Materials Recovery Facility
Safety Observation Form

Date: Wednesday, July 6th, 2016

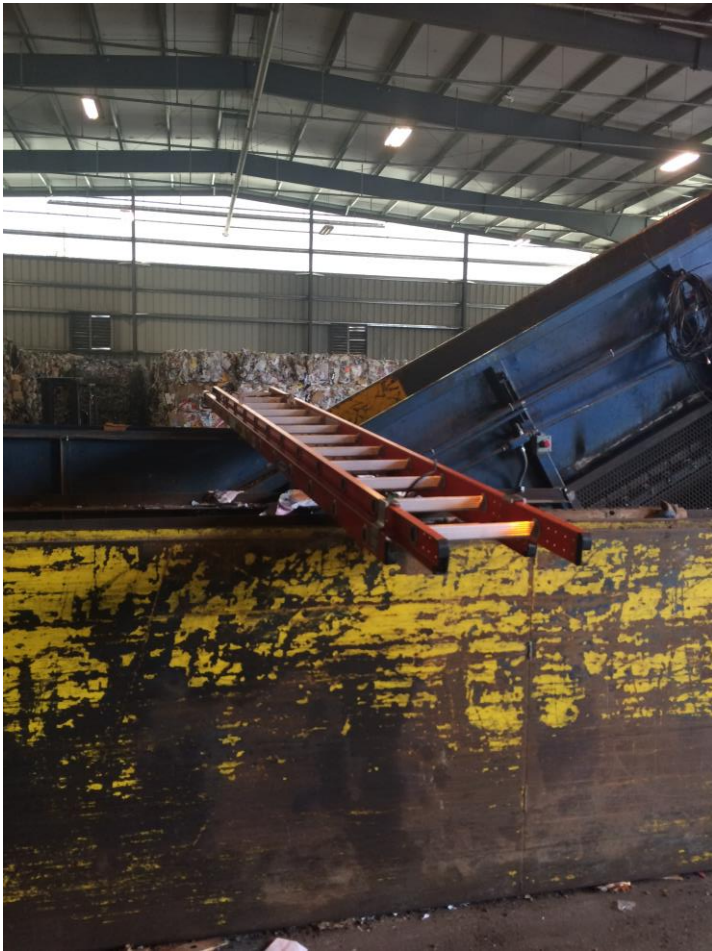
CG cylinders stored less than 20 feet
from flammables/combustible
materials (NFPA 51 2-2.1, 2-4.1)

Top left: Ladder storage

- Improper storage
- Ladder looks as though it may have been set up for use as a platform. Did not witness anyone using it as such, but 1910.26(c)(3)(vii) prohibits the use of ladders as platforms, gangways, etc.

Top right: Fire extinguisher in red rental forklift has no inspection details. Zip tie around the neck suggests there was a tag there at one point, but it has since fallen off. Also, the label is peeling away near where the serial number is located.

Bottom: Dumpster parked against (newly replaced) steel support beams. Dumpster door is also pinned shut.

New wall presents possible clearance issue. 20 CFR 1910.303(g)(1)(i)(B) states:
“The width of working space in front of the electric equipment shall be the width of the equipment or 762 mm (30 in.), whichever is greater. In all cases, the working space shall permit at least a 90-degree opening of equipment doors or hinged panels”
